**RE: Lot 12 Block 6 Volcano Cliffs Unit 18 SAD 228  
6528 Kimmick Dr. NW  
Grading and Drainage Plan  
Engineers Stamp Date 5/12/2020 (D10D003M12)**

Based upon the information provided in your submittal received 6/17/2020, this plan cannot be approved for Grading Permit until the following comments are addressed.

| SHEET TITLE:  |  | GRADING AND<br>DRAINAGE PLAN   |  |                |  |                       |  |            |  |

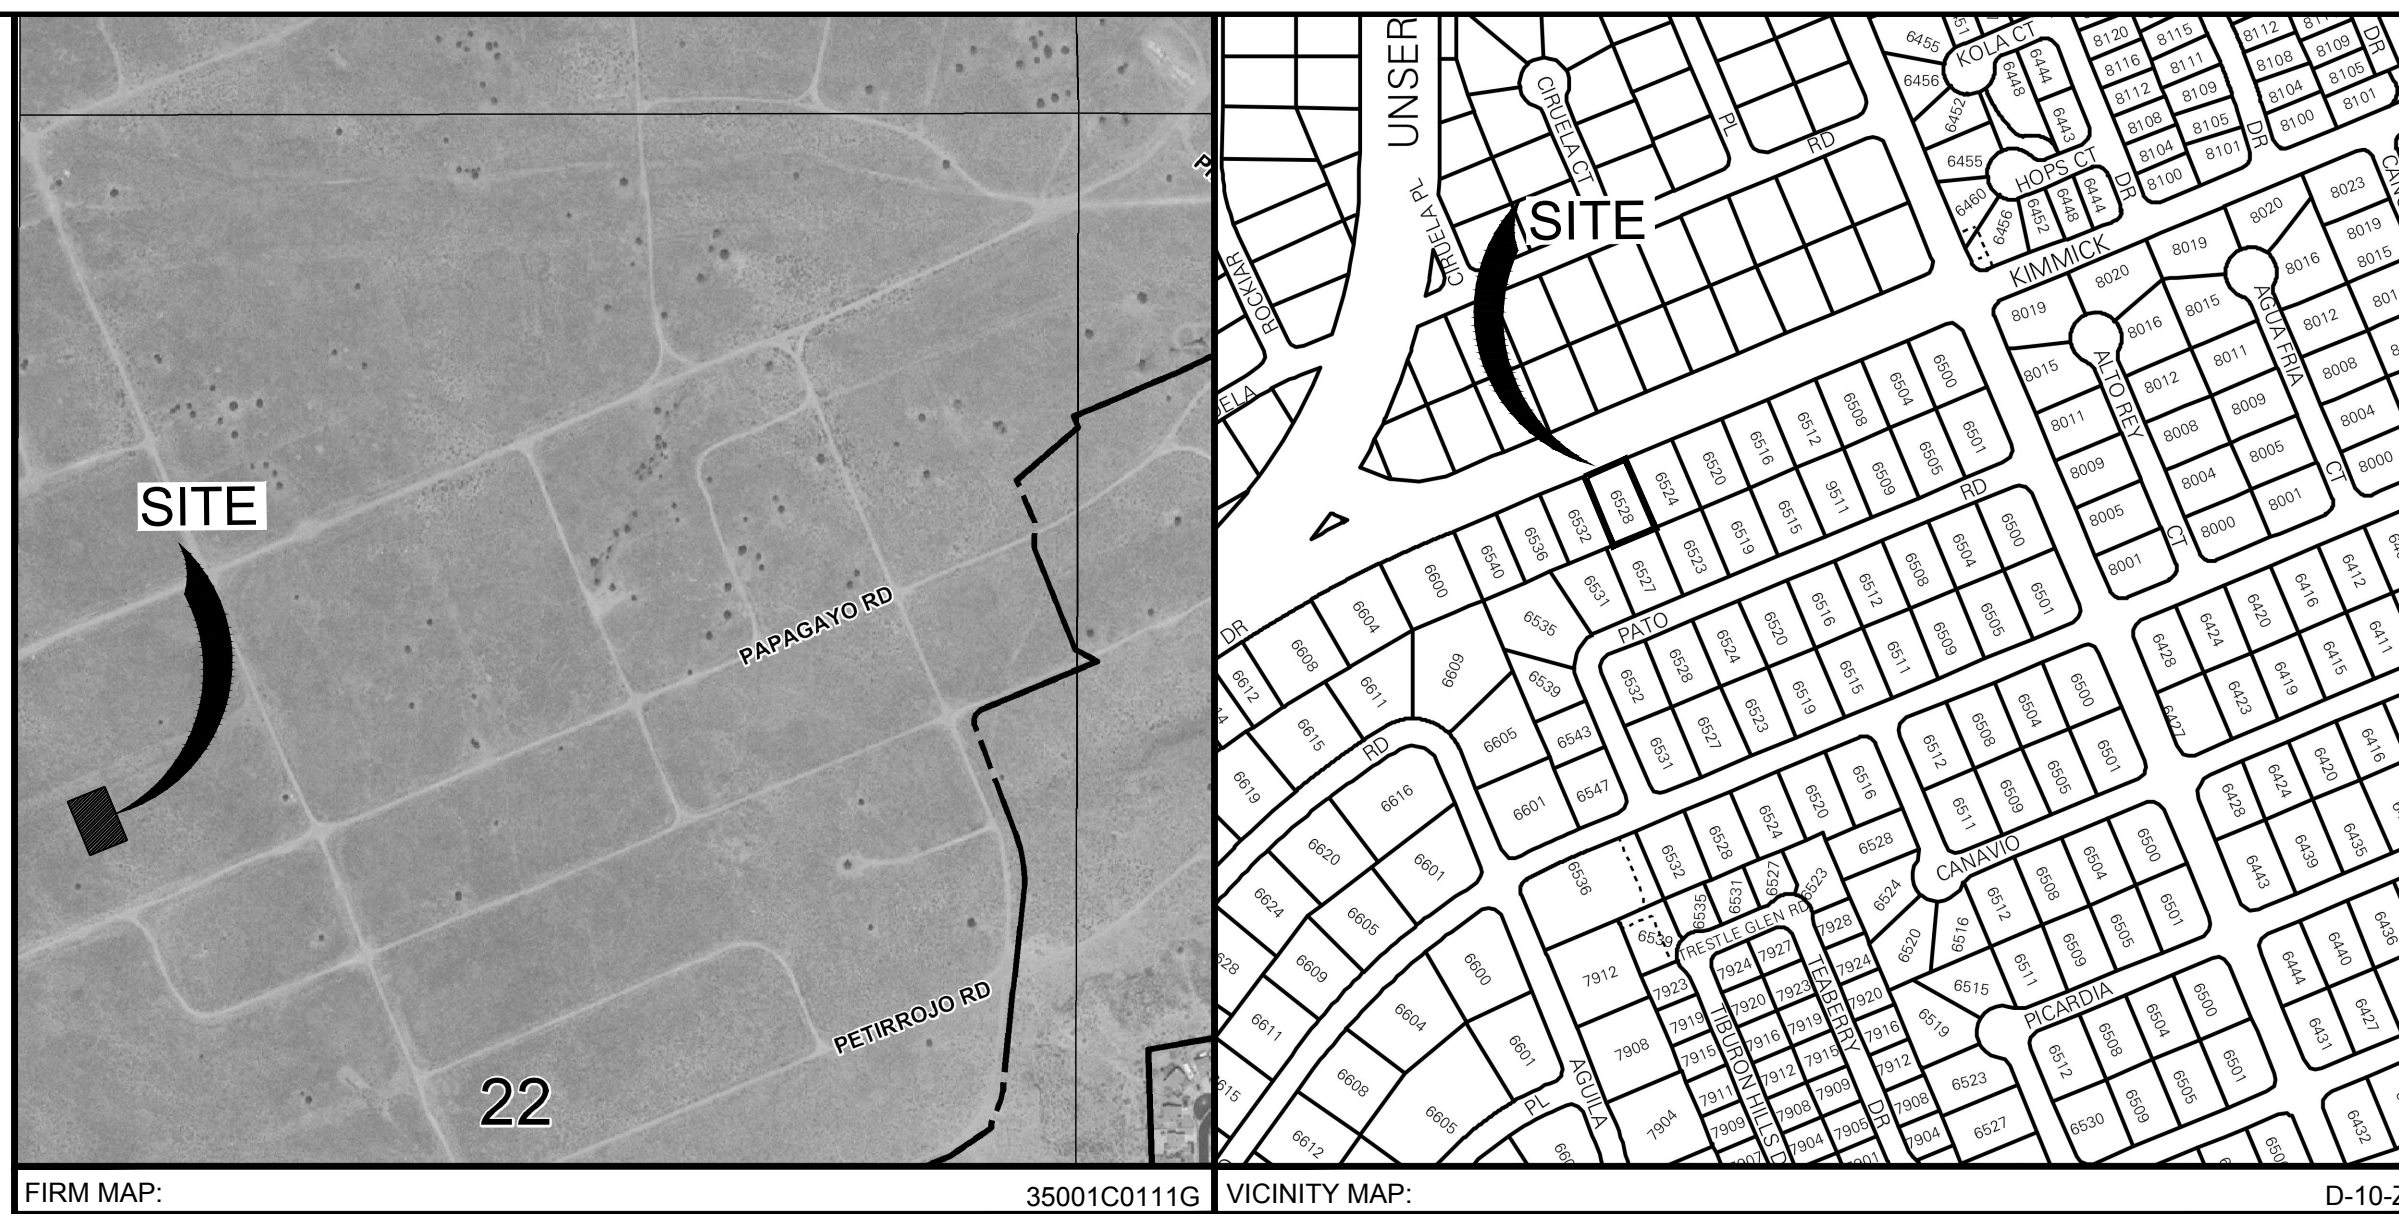
- Provide clarification for note 1
- Provide a description for Darkened line.
